**Re DA 169/2016
Camden Vale Milk Depot**

**Demolition, alterations, additions to the existing Camden Vale Milk buildings
for five new restaurants and a function centre, provision of car parking, associated
tree removal, landscaping and site works**

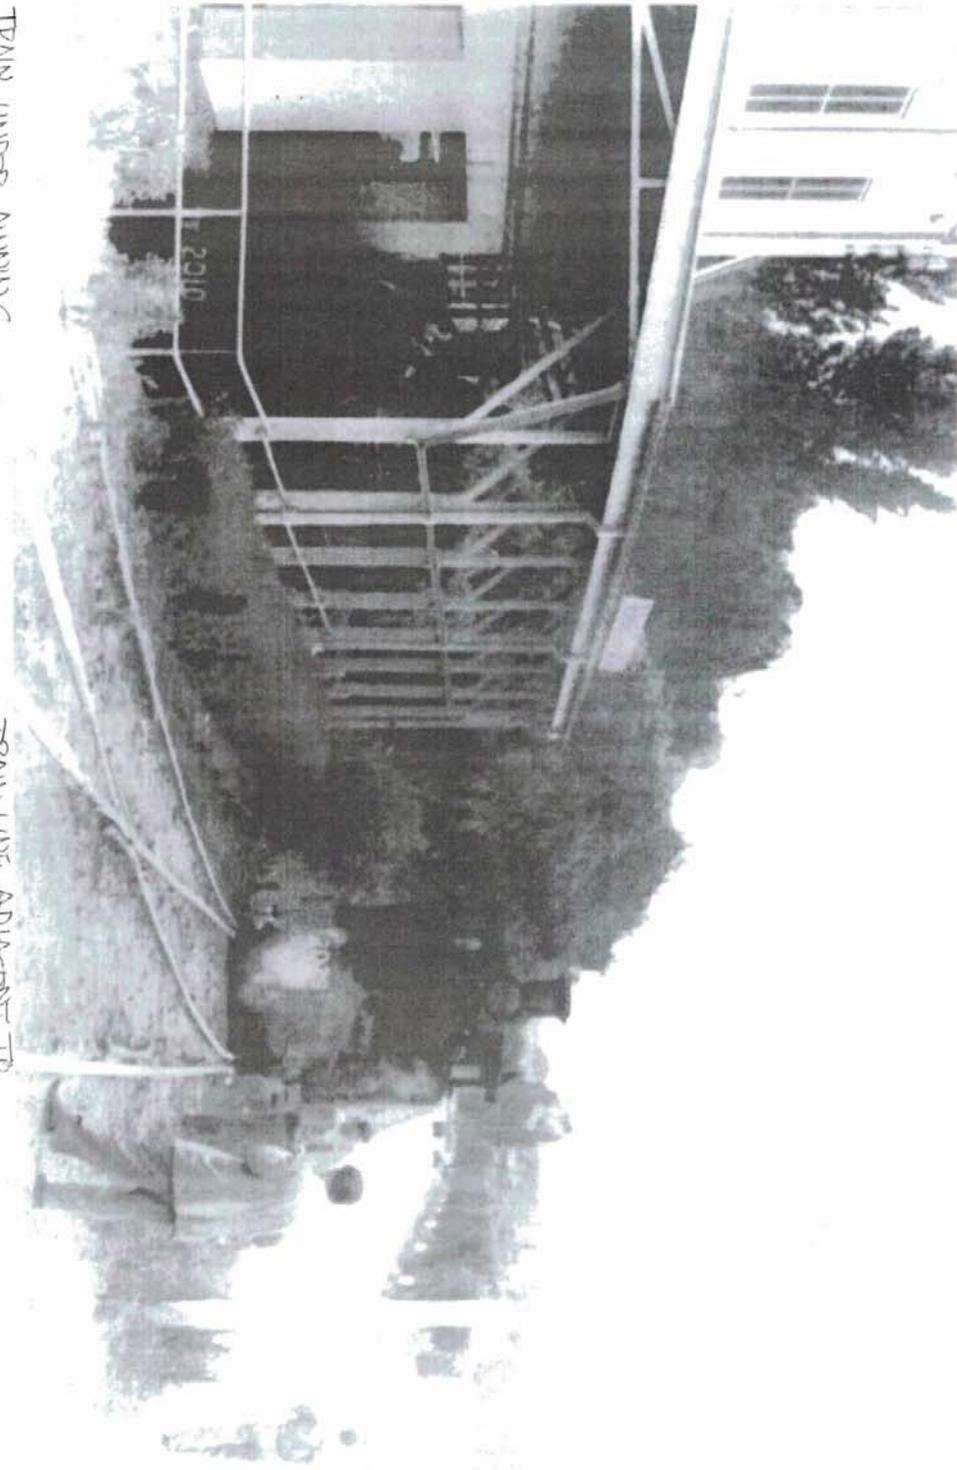
The proposed landscape plan is completely inadequate and inappropriate for this key position at the entry to Camden. Despite the objective of 'incorporating iconic elements of Camden's rural charm' this is merely lip service. The Argyle Street frontage has no proposed tree plantings and features only a low (presumably hedge) planting of Buxus and Indian Hawthorn. The plan should at least consider continuing the established Chinese Tallow (*Sapium Sebiferum*) trees that currently exist between this location and the Cowpasture Bridge. The plan is largely made up of generic landscaping plants and only includes one Jacaranda and one English Oak.

As well as the other very significant heritage issues and objections the landscape plan needs a complete revision and closer consideration of presenting a unified and sympathetic streetscape at this important entry point.

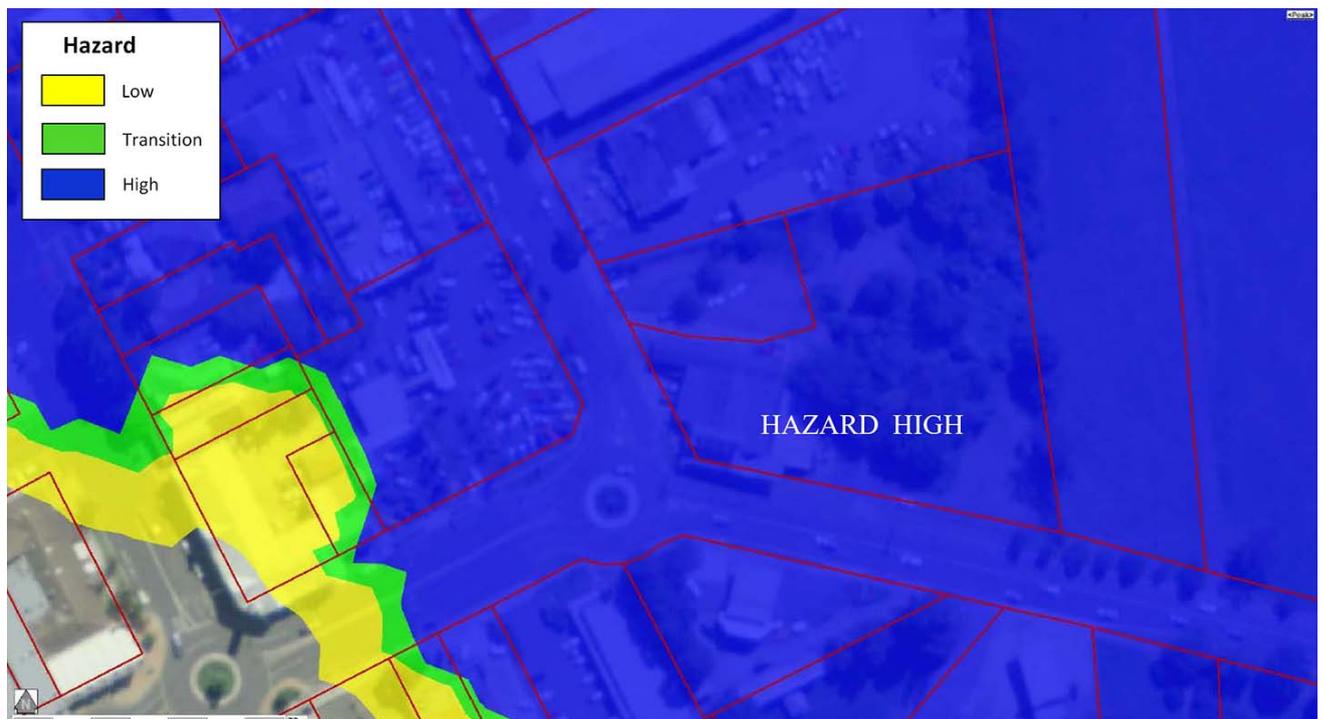
The Flood Risk Management Report (February 2017) maintains that only the lower area of the site is in a floodway and that the proposed building is to be located in a flood storage area. This is demonstrably not true as shown in our objection of 17 June 2016. In a large flood the water would be moving quickly – possibly with large dead logs floating with the fast current which would break through the glass doors.

1% AEP Hydraulic Category – Nepean River

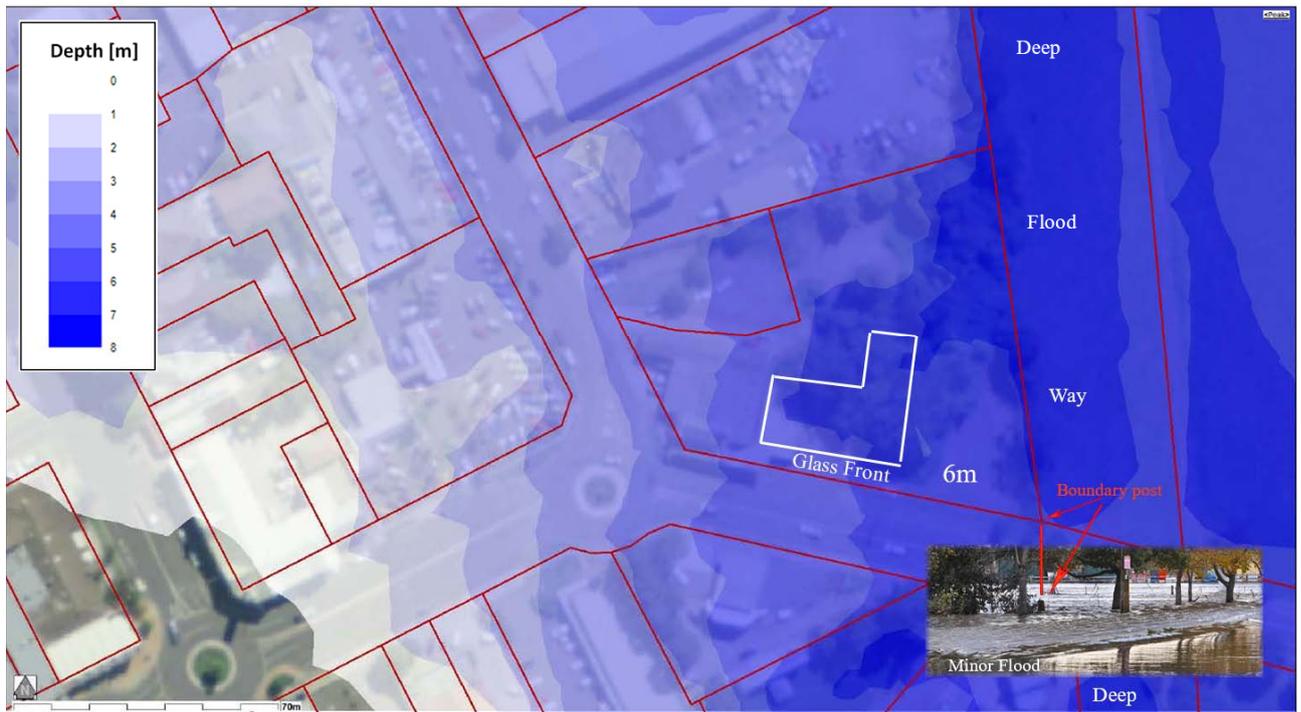
We note the amended Flood Risk Management report designates the area for the building addition as being in the hydraulic category of "flood storage", but this does not concur with our lived understanding and documentation of flood behaviour on the site. Comments have been added to information below as supplied in the report.

It is unclear how the retention basin is to work or where it is to be sited as the plans only show a storm water easement. It is entirely unacceptable to divert fast flowing water to other properties by placing a substantial building in the path of a flood.
